D1300595 HALF WAVE PLATE MOUNT, HAM1, aLIGO, PART PDM REV: X-002, DRAWING PDM REV: X-003

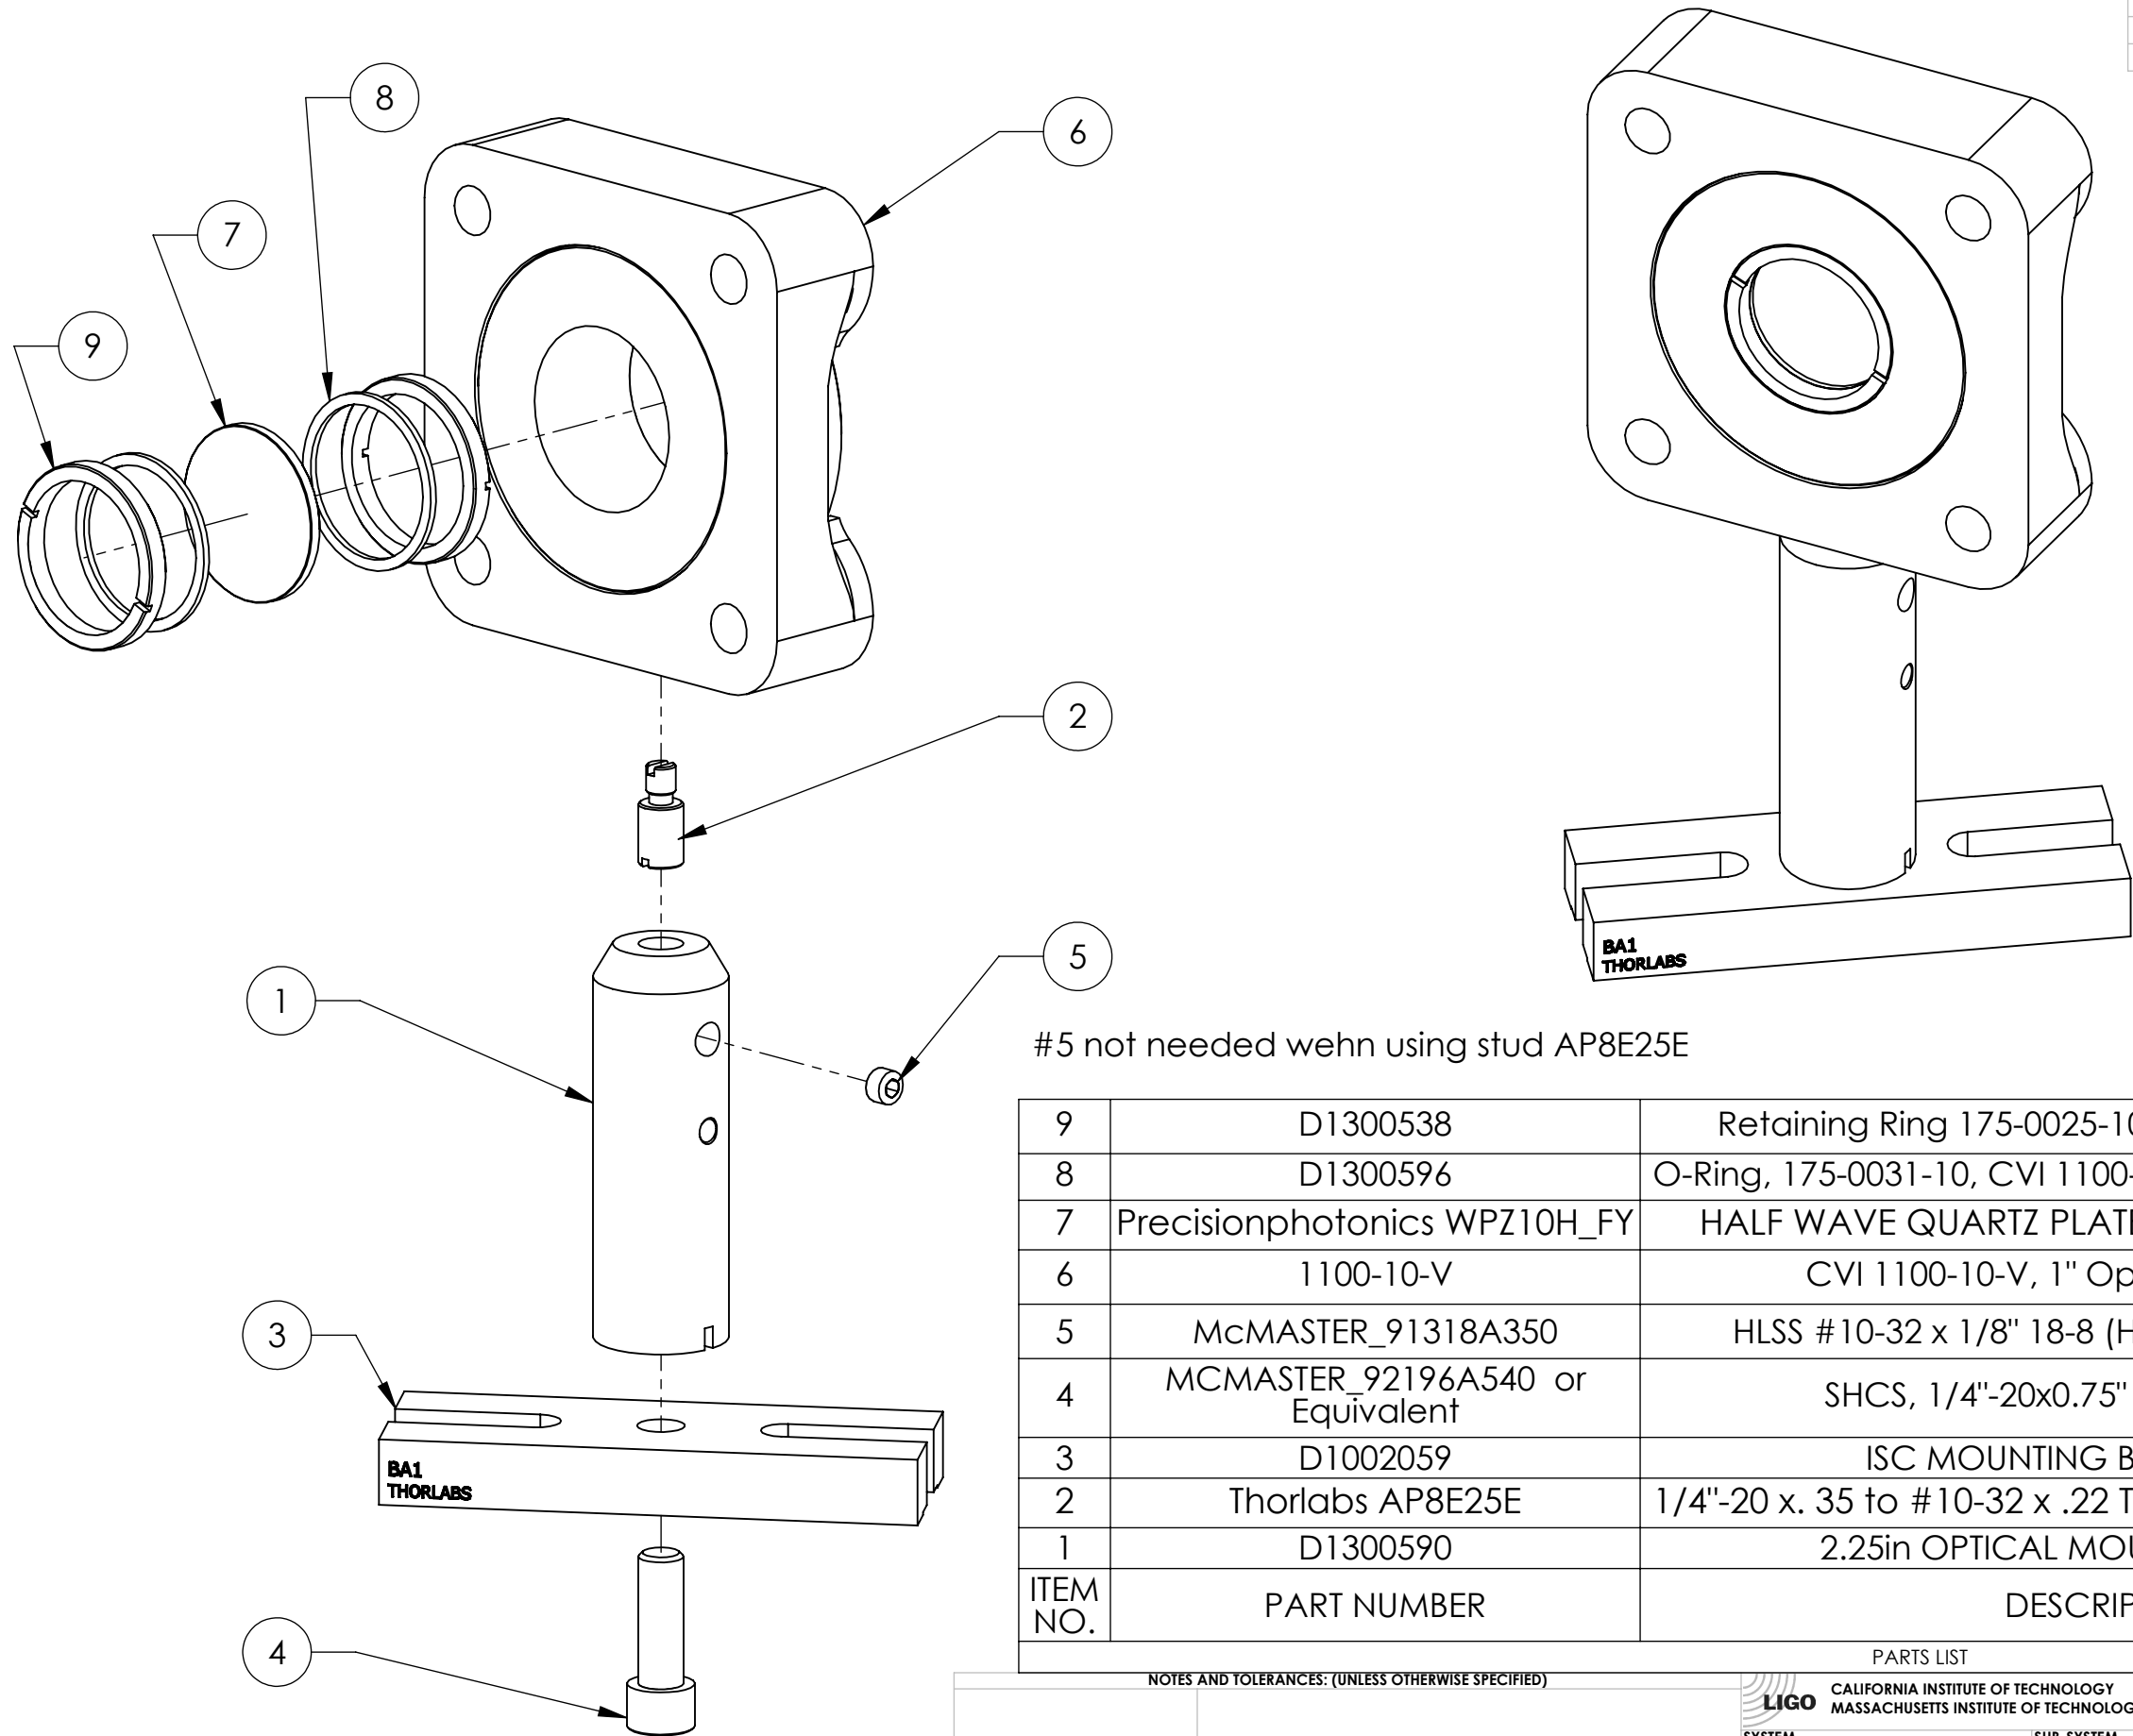
#5 not needed wehn using stud AP8E25E
